Appeal of Building Permit
2015-000030 BA
2910 Rio Grande

City of Austin Residential Permit Application Master Comment Report

Original Submittal Date: July 2, 2014
Application Expiration: December 29, 2014
Comment-report Sent Date: July 10, 2014
Comment-report #: 1
Property: 2910 RIO GRANDE ST
Case #: 2014-069694 PR
Case Manager: Shahin Moezzi
Manager Contact: Shahin.Moezzi@austintexas.gov

SUBJECT: Appeal of Building Permit Approval at 2910 Rio Grande Street

SITE PLAN
SCALE 1/16" = 1'-0"

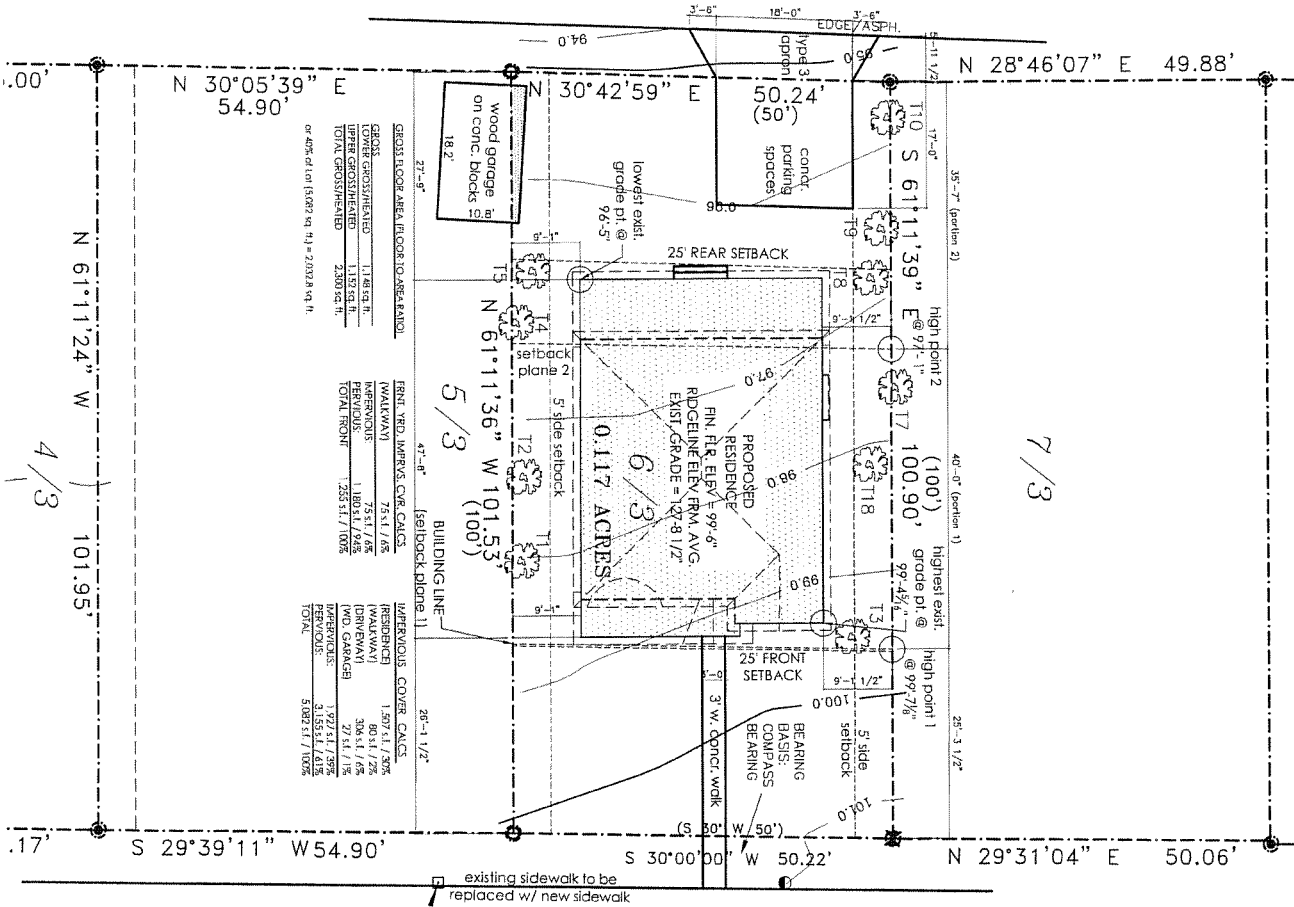
2. The proposed type 1 apron design does not comply with standards and will have to be revised in such a manner to demonstrate that the proposed apron's required returns or flares do not cross an adjacent property line. See Transportation Technical Criteria Manual online for acceptable Type 1 apron designs and applicable standards. Your proposed type 1 apron will have to be shifted to the right to meet standards. Revise accordingly.\

3. A sidewalk inspection will be required for this project.
4. Use of driveway runners is acceptable; however, they should be solid all the way with no space/breaks between the two tandem parking spaces that you are proposing. Revise accordingly.

5. On the plot plan and the building elevations with tent exhibits, provide and label the topographic elevation values for both Tent 1 high point/grade and Tent 2 high point/grade.

6. Provide a front yard impervious cover table to demonstrate compliance with LDC 25-2-1603 which was adopted by the West University NP.
7. The McMansion/Sub-Chapter F building line was not started at the correct location. See Sub-Chapter F 3.2 for directions on where to start it.

8. Why does the plot plan depict the existing curbing running through one of the proposed driveway runners? Do you plan to leave it there? Based on google street-view – it appears that your

neighbor's fence will also have to be relocated to accommodate your proposed new parking spaces.
